April 8, 1992

Attached is the tolerance analysis of the "P" cable connection regarding our suggested changes to improve wipe. Molex feels this change is 100% compatible with all product already installed in units. But to be sure, we should ask all manufacturers of this connector to review this tolerance analysis for compatibility with their design.

PROPOSED SCREW LOCK HEIGHT FOR SCSI-3 "TYPE P" CONNECTOR

FIG.2: PROPOSED SCSI-3 -
(NOMINAL LAYOUT)

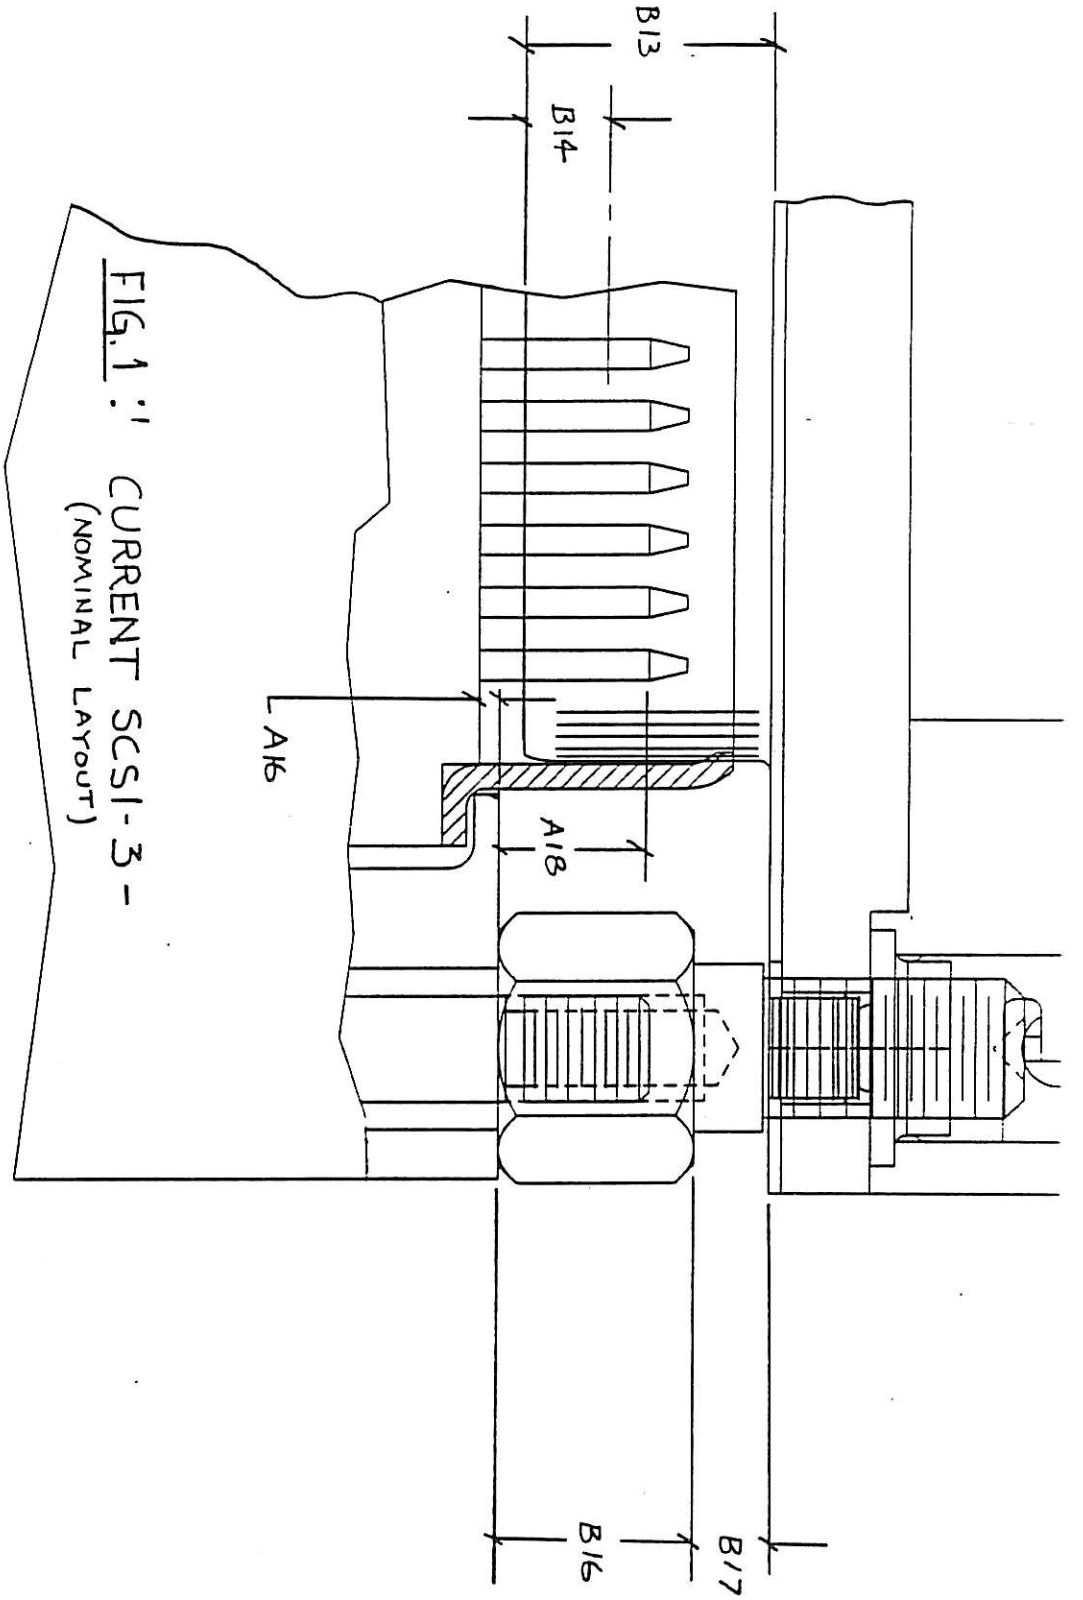
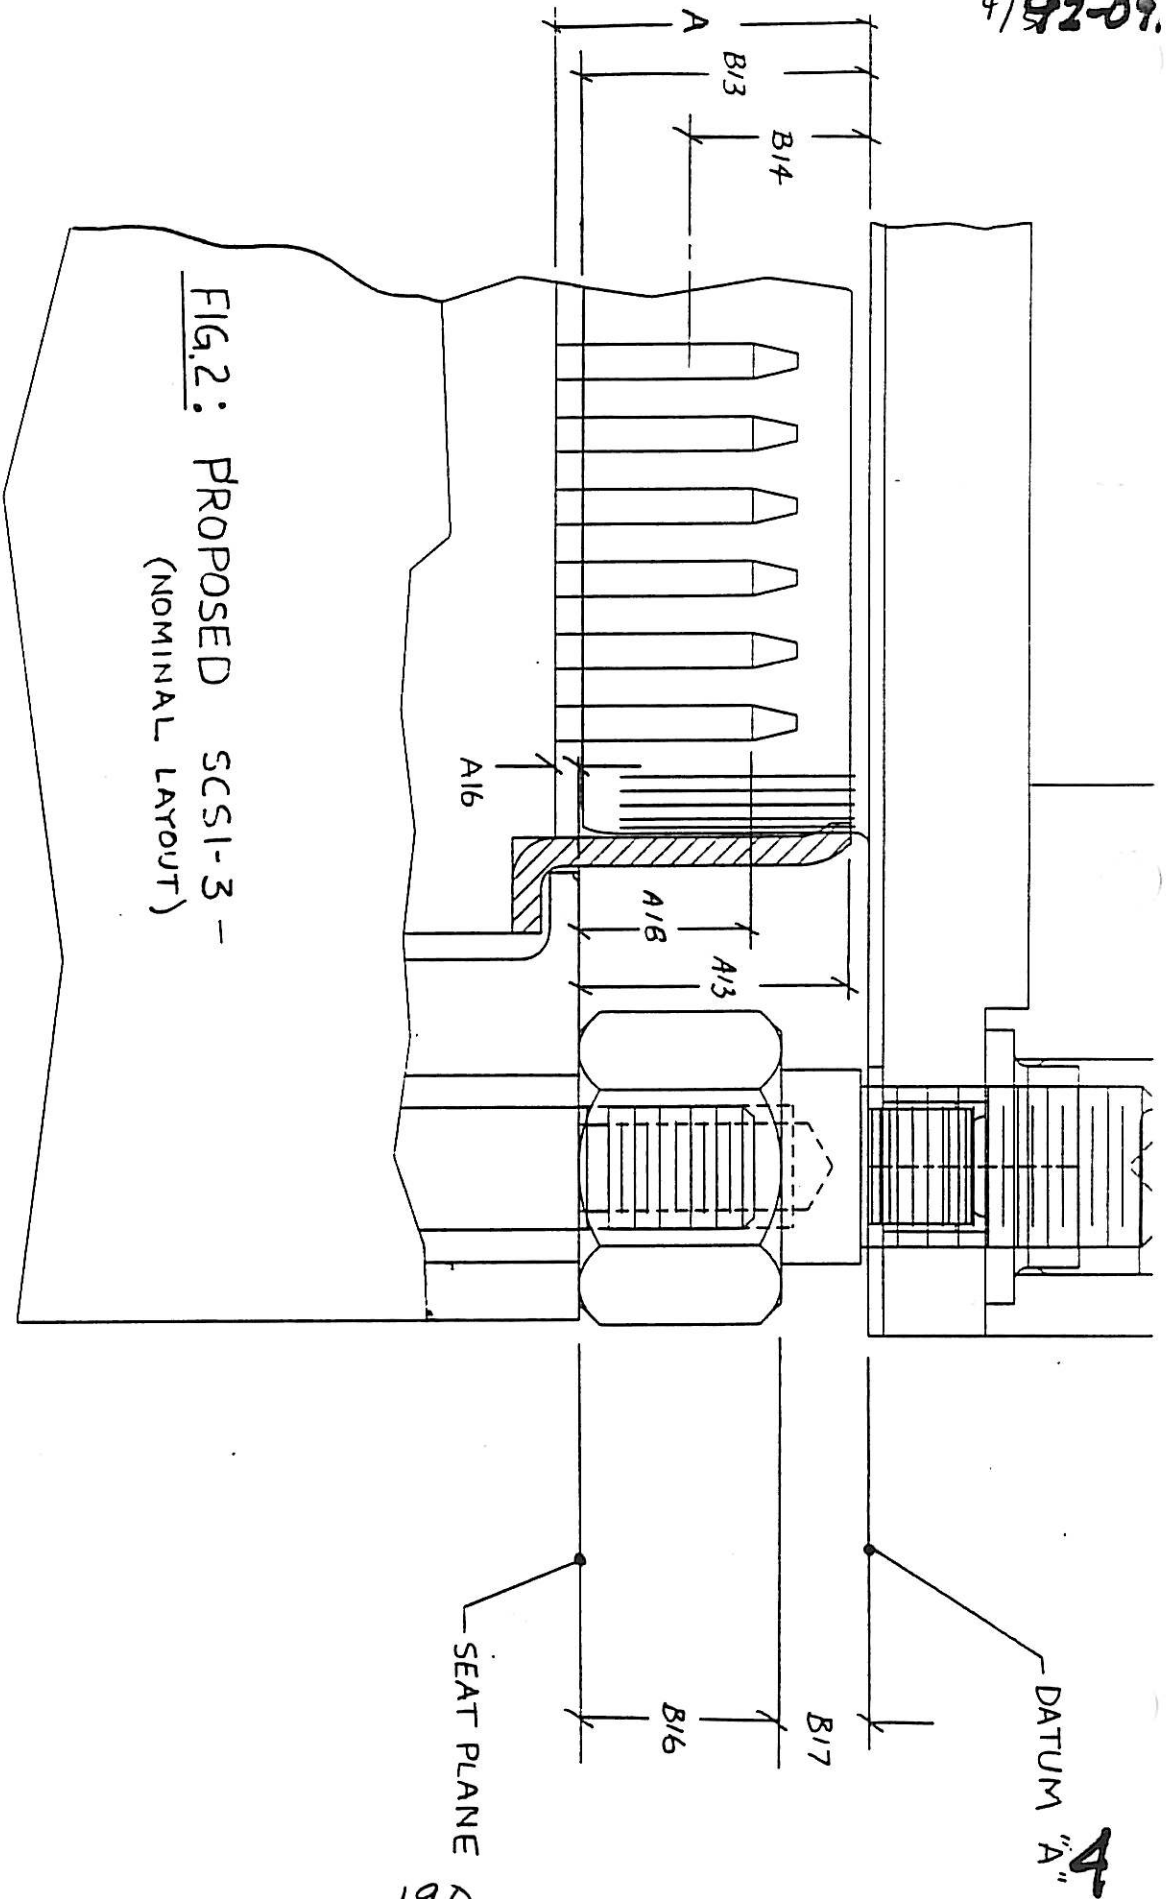
FIG. 1: CURRENT SCSI-3 -
(NOMINAL LAYOUT)

$$\begin{aligned}
 \text{WIPE} &= A18 - [(B16 + B17) - B13 + B14] \\
 &= .104 \text{ MIN.} - [(.157 \pm .002 + .060 \pm .005) - .197 \pm .005 + .065 \text{ MAX.}] \\
 &= .019 \pm .012 \text{ (WORST CASE.)}
 \end{aligned}$$

$$\begin{aligned}
 \text{WIPE} &= B14 - (B16 + B17 - A18) \\
 &= .135 \pm .007 - (.146 \pm .002 + .060 \pm .005 - .113 \pm .009) \\
 &= .042 \pm .013 \text{ (RMS)} \\
 &= .042 \pm .023 \text{ (WORST CASE)}
 \end{aligned}$$

III. FIND: DIMENSIONS: "A" AND "B16"

IV. SOLUTION:

$A = B17 + B16 + A16$

BY REQUIREMENT #2: $B17 + B16 + A16 \geq B13$

THEN: $.060 \pm .005 + B16 \pm .010 \pm .005 \geq .197 \pm .005$
 $B16 \geq .202 - .055 - .005$
 $B16 \geq .142$

LET: $B16 = .144 \pm .002$

THEN: $A = .060 \pm .005 + .144 \pm .002 + .010 \pm .005$
 $A = .214 \pm .007$ (RMS)

BY REQUIREMENT #3: $.214 \pm .007 - .010 \pm .005 \leq .060 \pm .005 + .144 \pm .002$
 $.204 \pm .009$ (RMS) $\leq .204 \pm .007$

SO: ADD .002 TO B16 TO COMPENSATE

THEN: $B16 = .146 \pm .002$

BY REQUIREMENT #4: $.193 \pm .004 \leq .146 \pm .002 + .060 \pm .005$

$.197$ MAX. $<$ $.199$ MIN.
